**ADDENDUM NO. 4**

**MOCCASIN BEND WASTEWATER TREATMENT PLANT  
DETRITORS REHABILITATION  
CONTRACT NO. W-15-001-201**

**CITY OF CHATTANOOGA, TENNESSEE**

SHEET  
G5.2 of G5

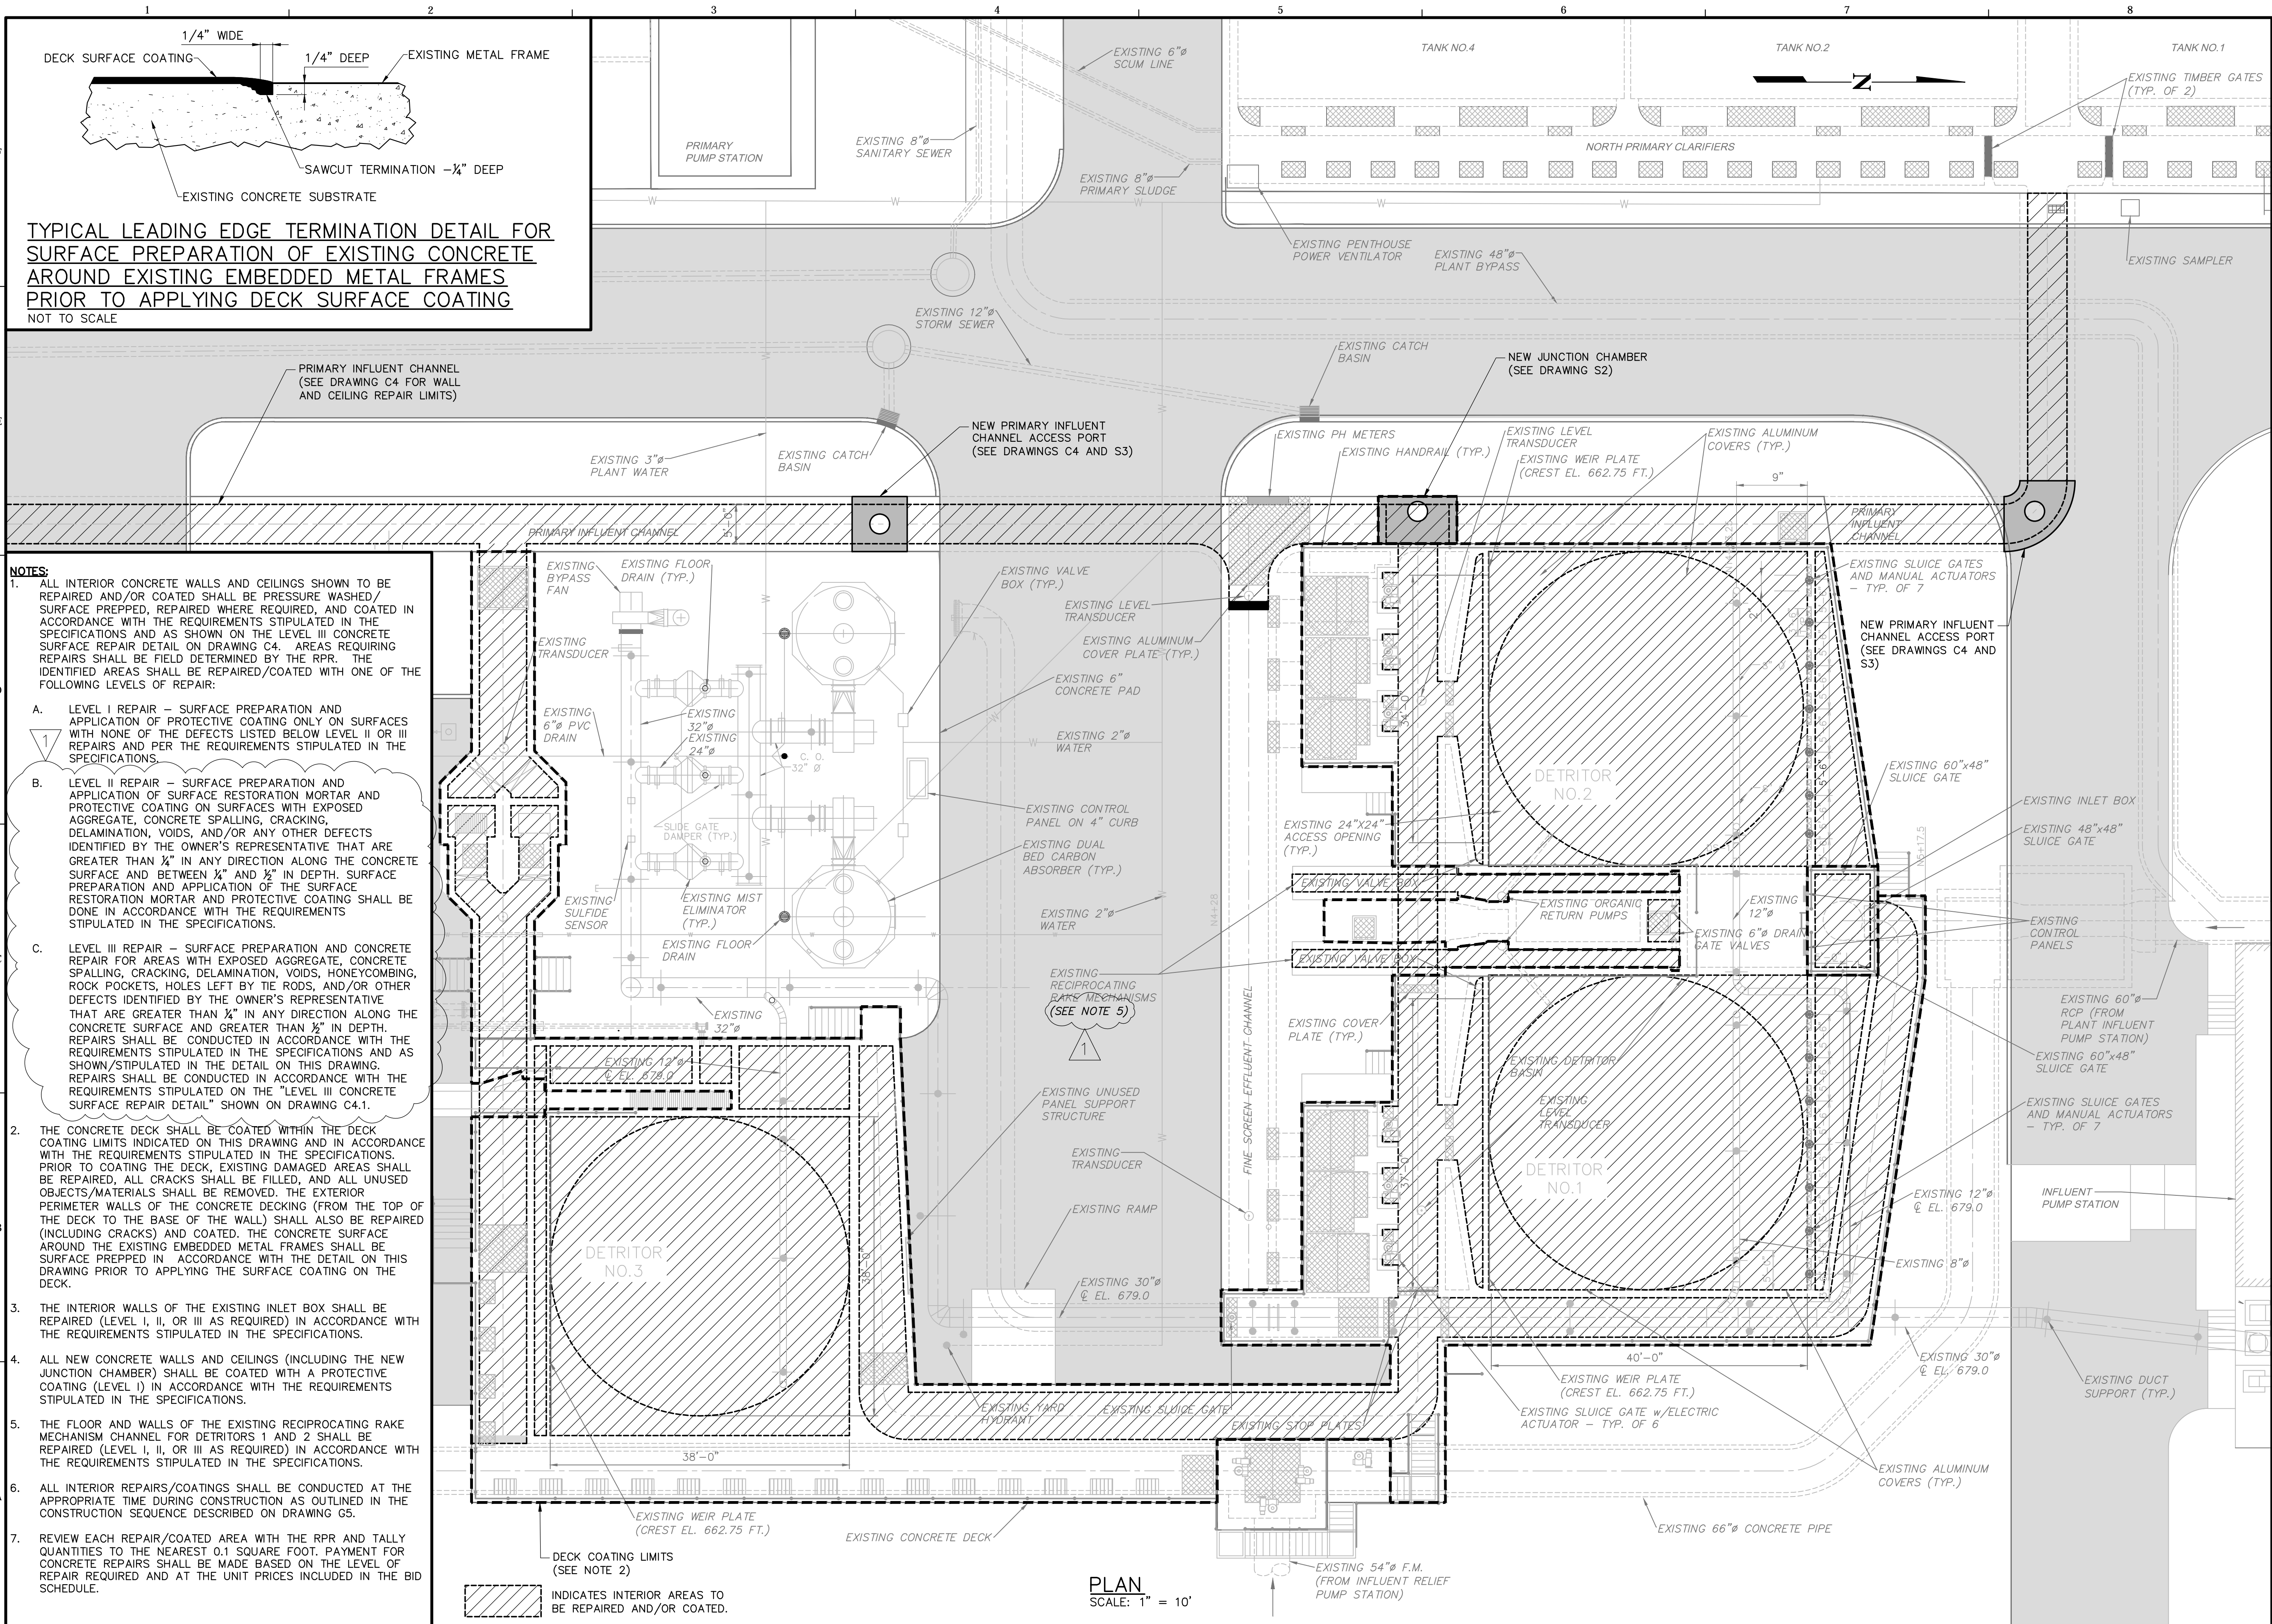
- G. *Drawing G5.1 (Construction Sequence), "Minimum Temporary Bypass Pumping Requirements" for handling both the North & South Recycle Pump Station Flows.***

1. How long can these pump stations be completely turned off (shut down) in order to determine "best" plans for tying into or bypassing around the pump station force mains?
2. What portions of the road to the west of the detritor complex be closed to allow for installation of temporary bypass piping?
3. Where can the flows from these pump stations be temporarily routed/discharged?
4. What quantities of grit and/or organics (sludge) should the contractor anticipate having to remove/dispose in the detritor basins and influent/effluent/bypass/distribution channels once they are drained?

2. Task 1.H – When is Gate “C” ever open so that it needs to be closed during Task 1? Isn’t Gate “C” always closed for this task? Isn’t Gate “C” always closed during the construction of this project?

3. Task 3.4 – Aren’t Primary Clarifiers 1-4 the “north” clarifiers, not “south”?
4. Task 5.4 – Aren’t Primary Clarifiers 5-8 the “south” clarifiers, not “north”?

5. Task 5.7 – Shouldn’t a task including “close Gate “O”” precede Task 5.7?
6. Regarding flows from the onsite Influent Pump Station. It appears that flows from the onsite Influent Pump Station have three (3) possible routes – one (1) to the existing Detritor Inlet Box, one (1) to the existing 66” concrete pipe, and one (1) to the existing 48” Plant Bypass. Is it of any concern to bidding contractors that no mention or discussion of flows to/from the existing 48” Plant Bypass is addressed? With that said, do any flows to/from this 48” Plant Bypass line impact construction sequencing in any way? Must any flows to/from the 48” Plant Bypass line need to be handled by the contractor? Please clarify/advise.

1. 4 hours (max.) for both the north and south recycle pump stations.
2. The main road west of the detritors shall remain open. Access to the septage receiving area shall also remain open. See response in item 3 below and Drawing G5.2 (included in this Addendum) for proposed temporary routing of force main from the north and south recycle pump stations.

3. The north and south recycle pump force mains may be temporarily intercepted, re-piped, and re-routed as shown on Drawing G5.2 (included in this Addendum). The GC may propose other routes, however the alternate routes must be approved by the City and the Engineer.

1. The requested drawings have been added as Reference Drawings R18 through R22 (included above in this addendum).
2. Disregard Task 1.H. However, verify that Gate "C" is closed as required under Task 1.A. Correction has been made in Drawing G5.2 (included in this addendum).

3. Correct. Primary Clarifiers 1-4 are the "north" clarifiers. Correction will be made in Drawing G5.2 (included in this addendum).
4. Correct. Primary Clarifiers 5-8 are the "south" clarifiers. Correction will be made in Drawing G5.2 (included in this addendum).

5. A task involving closing Gate "O" prior to Task 5.7 has been added to Drawing G5.2 (included in this addendum).
6. Flows to/from the 48" Plant Bypass line should not need to be handled by the contractor and should not impact the construction sequencing.

SHEET  
**C3.1 of C5**

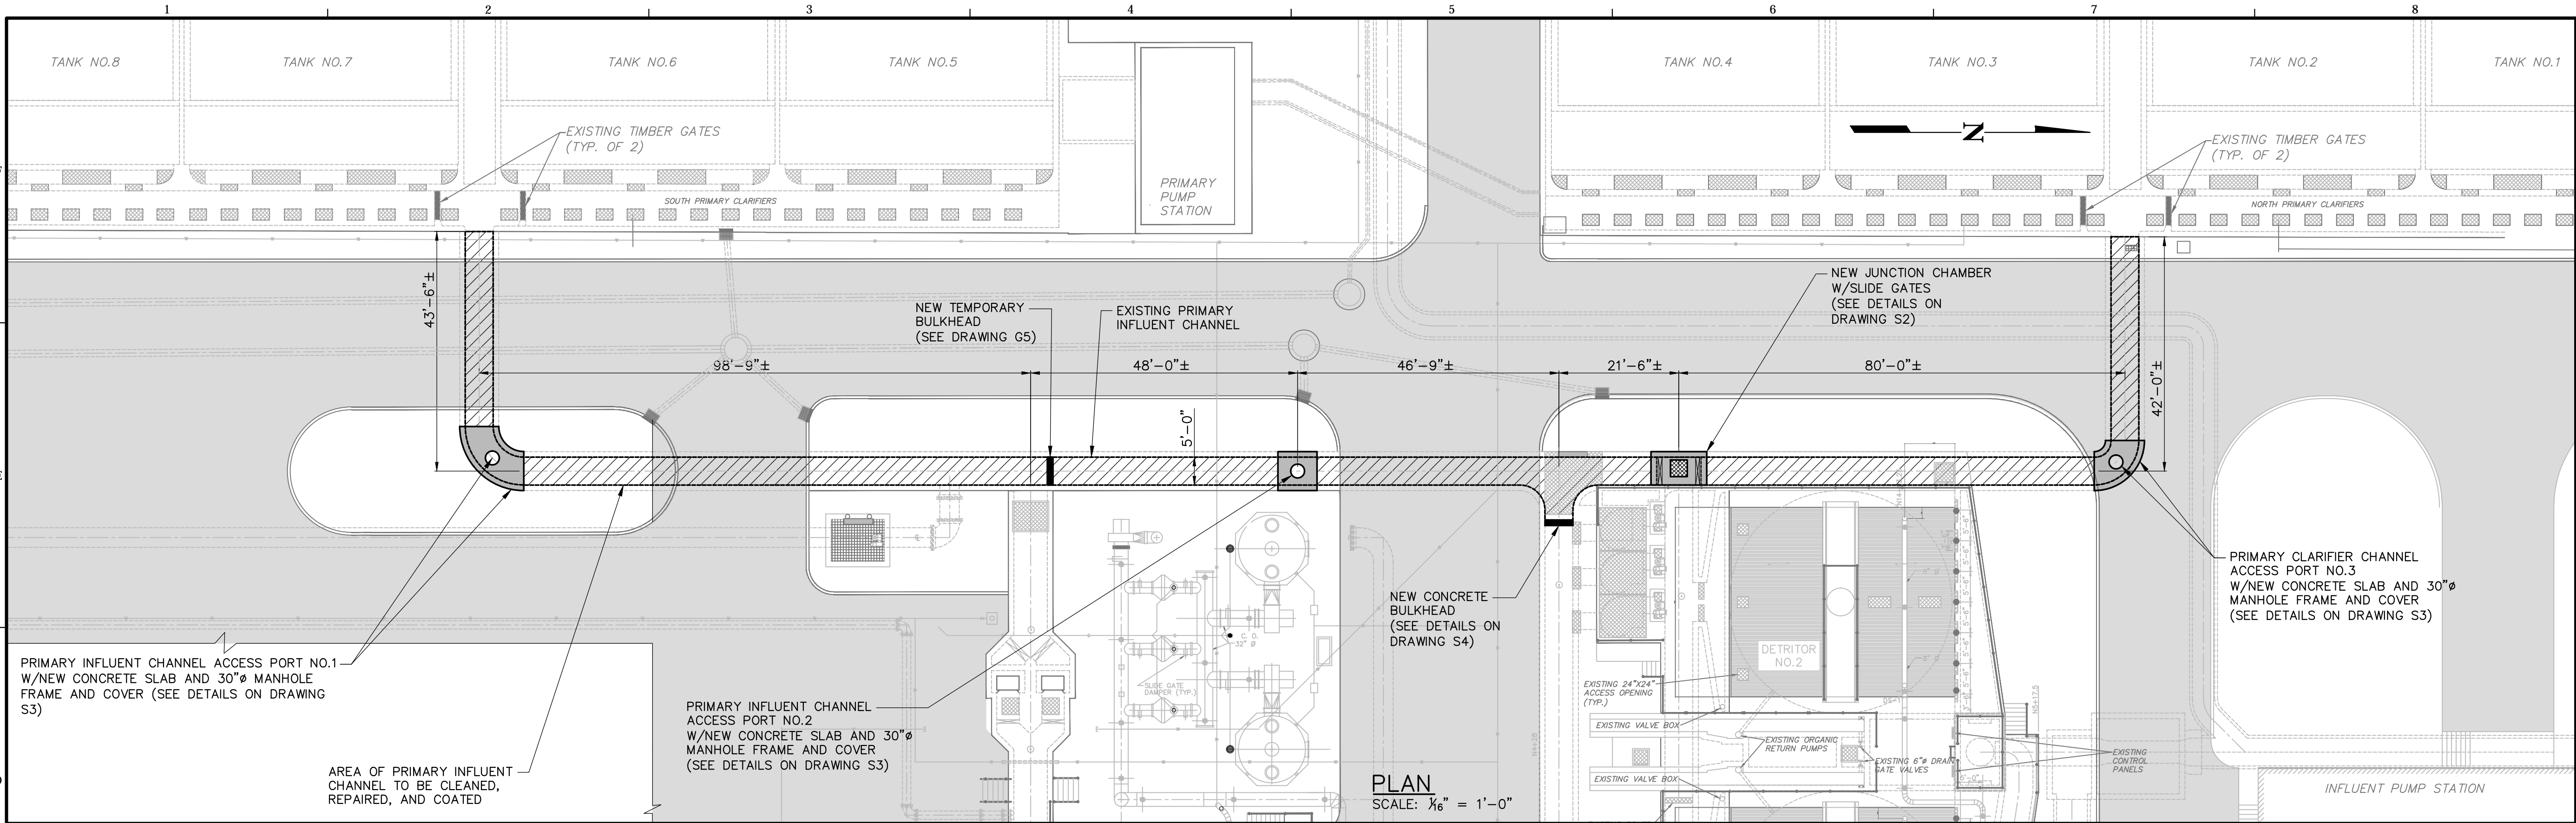
#### **H. *Drawing C3 (Site Plan - Concrete Surface Improvements), Note 2, Sentence 2.***

1. The exterior perimeter walls of the concrete decking are to be repaired and coated "from the top of the deck to the base of the wall". Is it the engineer's intent for the exterior perimeter walls to be repaired and coated in their entirety to the wall foundation slab or only the wall portion that is above grade and exposed to view? The indicated walls extend significantly below grade to their foundation. This would require excavation to expose the below grade walls. Please Clarify.

1. Only the wall portions that is above grade and exposed to view shall be repaired and coated.
